Document Title: Revised Addendum to the Revised Work Plan for East Ravine Groundwater Investigation, PG&E Topock Compressor Station, Needles, California

Response to Comments on August 27, 2010 Submittal

DOCUMENT REVIEW AND COMMENT RESOLUTION SHEET

Document Title	Addendum to the Revised Work Plan for East Ravine GW Investigation	**Document Date**	9/27/2010
		Originator, Organization and Phone Number	PG&E/CH2MHILL
Reviewer, Organization, and Phone Number	DOI – Contact /Pam Innis Project Manager, (303) 445-2502	**Review Criteria**	Technical and CERCLA Compliance

FIGURE 4
Estimated Implemenation Schedule
Revised Addendum to the Revised Work Plan for
East Ravine Groundwater
PG&E Topock Compressor Station
Needles, California

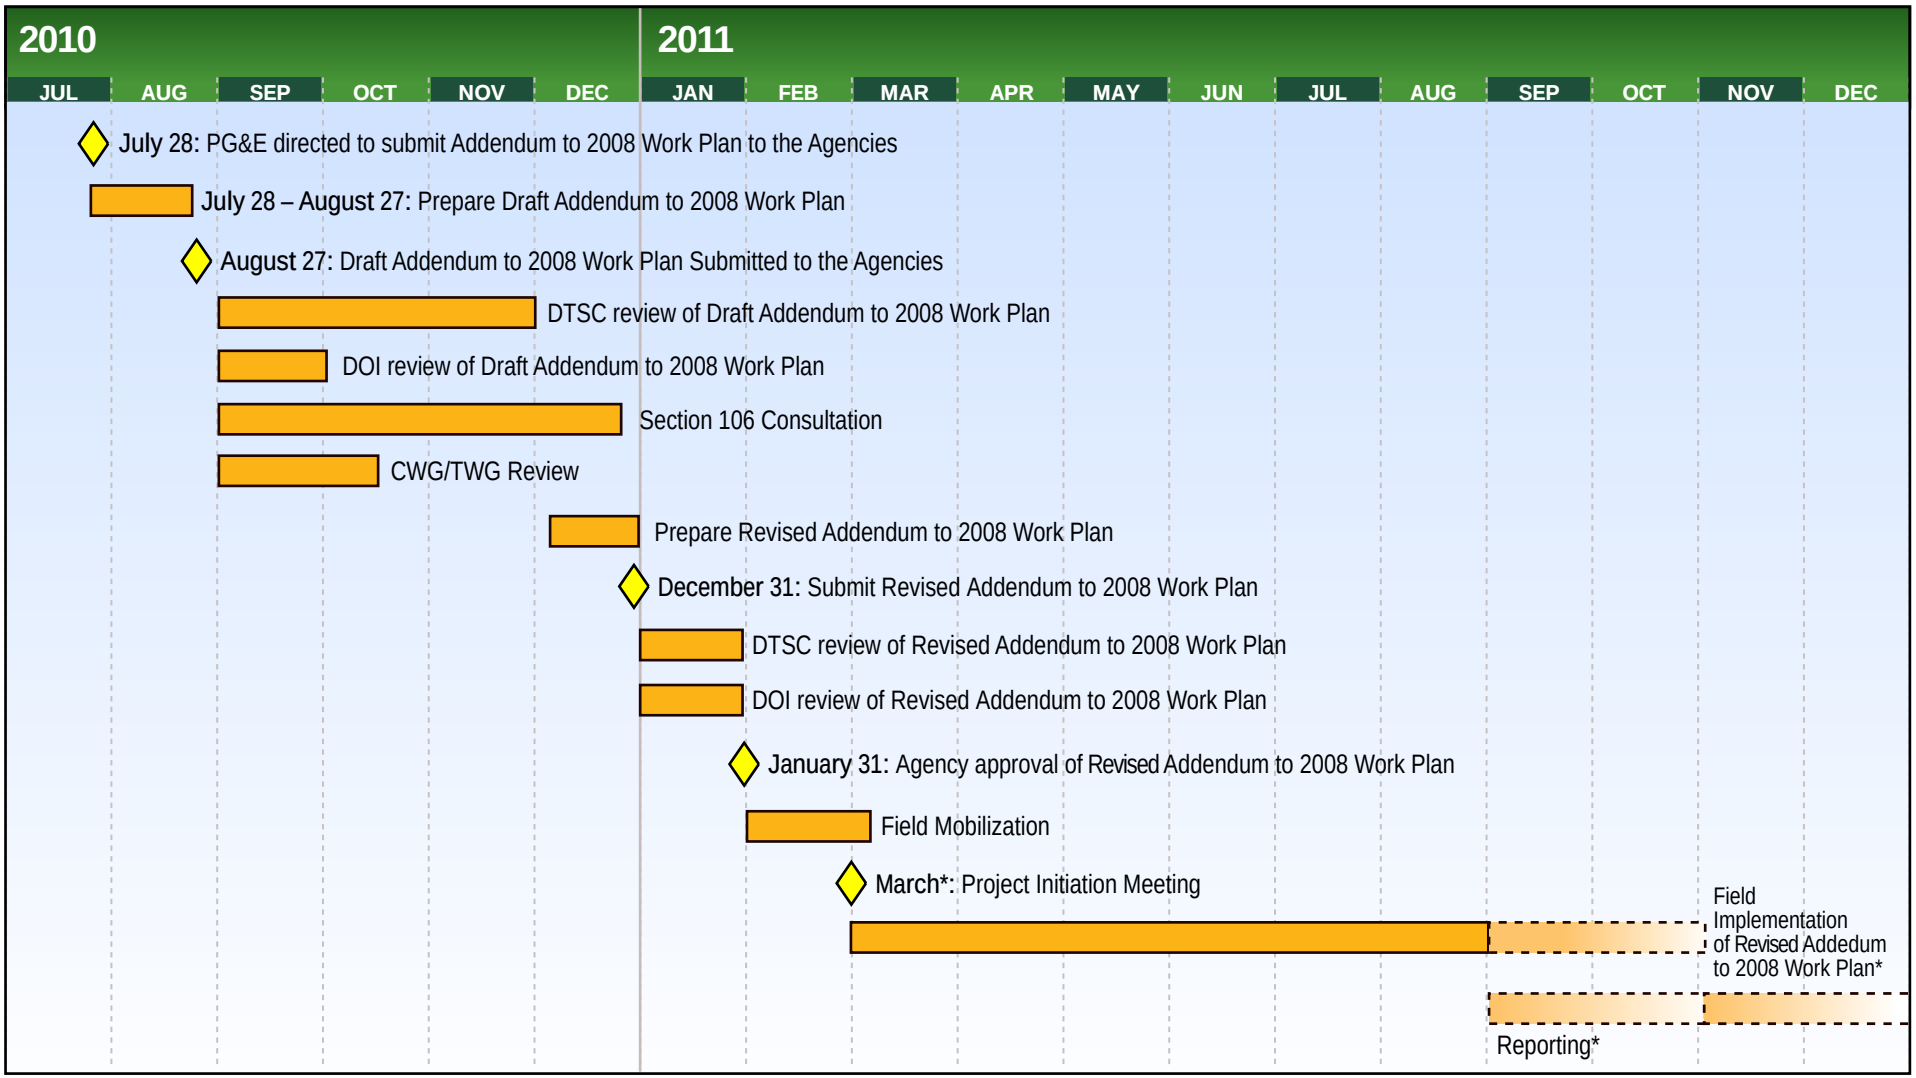
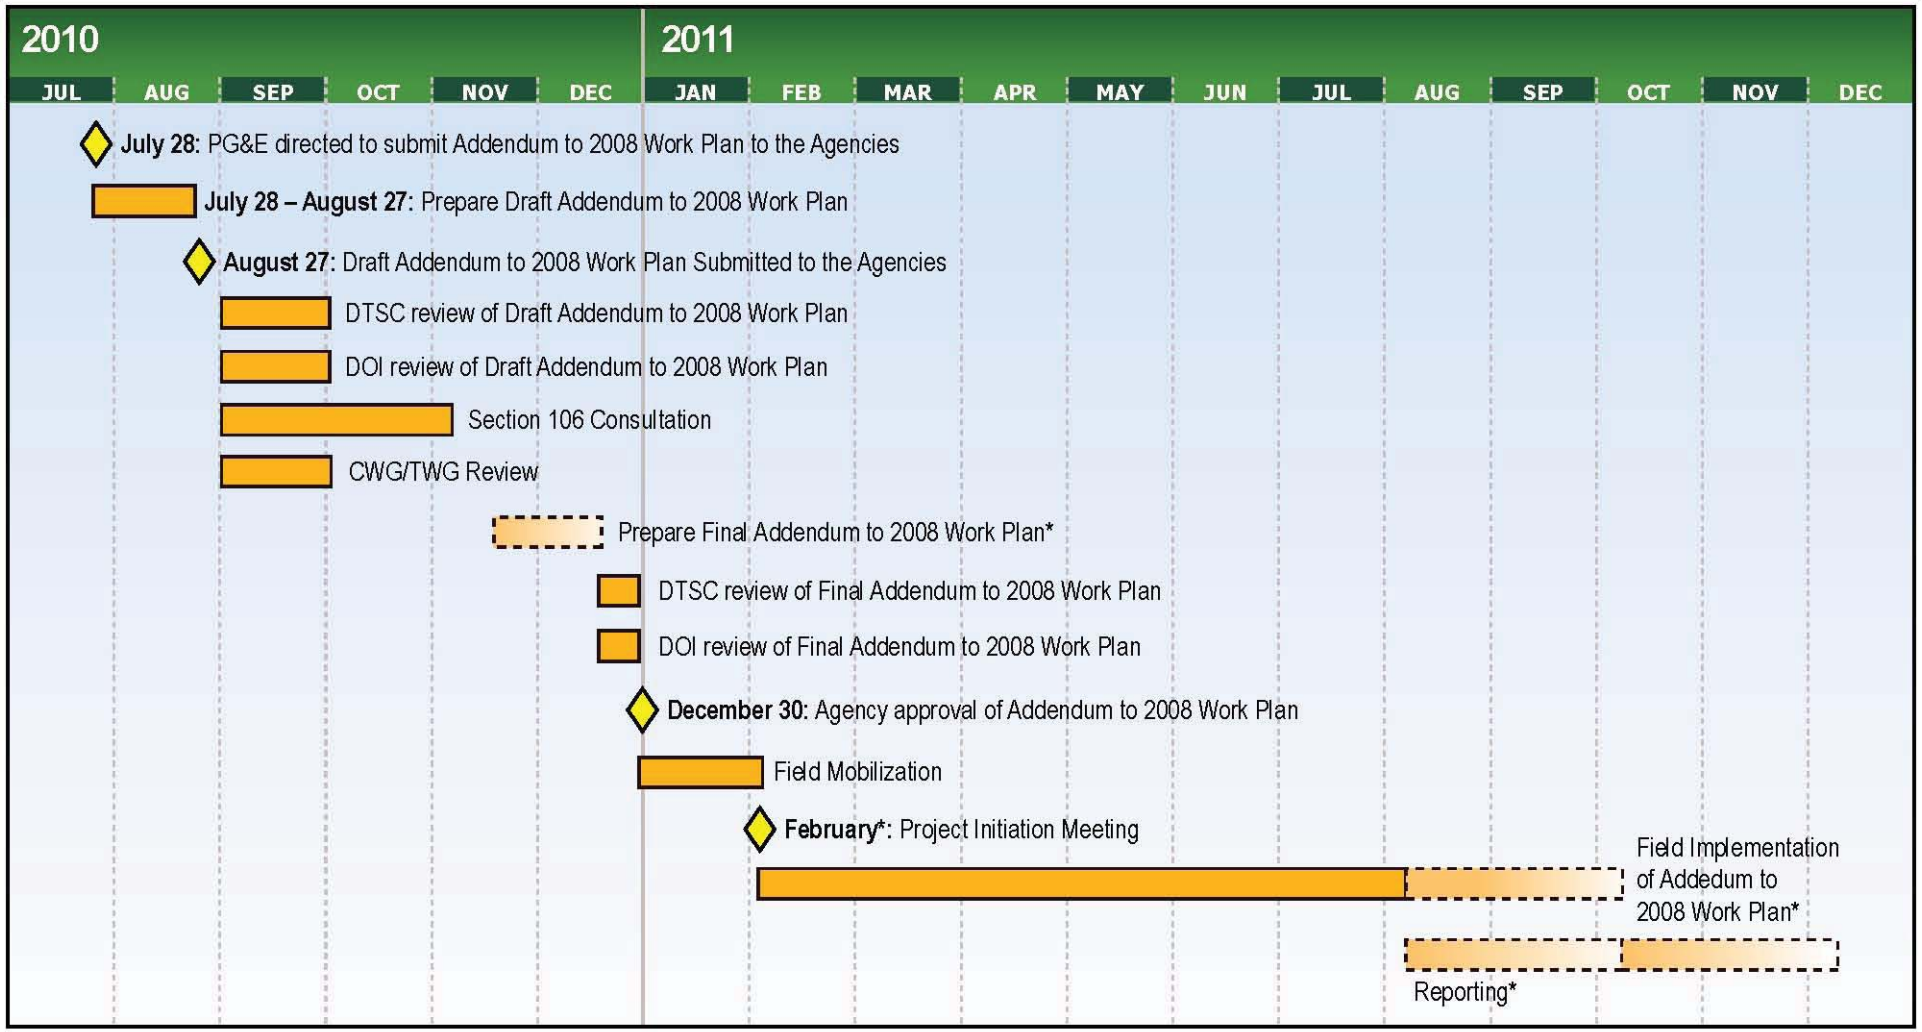
FMIT Oct-14 letter	FMIT 21	Section 106 Consultation (Figure 4 of the WP Addendum)	A related matter is the block for Section 106 consultation on the associated schedule (Figure 4). Do the agencies believe they have started this consultation? How do the agencies propose to finish it? Has a determination of adverse effect been made? Have they actually initiated consultation? Has anybody started negotiating toward a memorandum of agreement? These, again, are matters of major concern to the Tribe at this juncture and moving forward.	DOI	Section 106 consultation on the original work plan was initiated on August 11, 2008, and the approval letter was received from HNWR on November 10, 2008. BLM provided early information (via letter) to the tribes regarding implementation of further groundwater characterization efforts in the area of the East Ravine and the Topock Compressor Station on November 9, 2009. On September 14, 2010, BLM initiated formal consultation on the Addendum to the Revised Work Plan for East Ravine Groundwater Investigation and PG&E compressor station. Both of these consultations took place prior to the execution of the PA, which was on October 26, 2010, when the ACHP signed the document. Therefore, the consultation questions (comments FMIT 17 and FMIT 21) are in the context of pre-PA. Either way, the BLM has engaged in consultation with the tribes and CA SHPO. BLM has followed up with CA SHPO on requested items. No modification to the Addendum is proposed as a result of this comment.

A related matter is the block for Section 106 consultation on the associated schedule (Figure 4). Do the agencies believe they have started this consultation? How do the agencies propose to finish it? Has a determination of adverse effect been made? Have they actually initiated consultation? Has anybody started negotiating toward a memorandum of agreement? These, again, are matters of major concern to the Tribe at this juncture and moving forward.
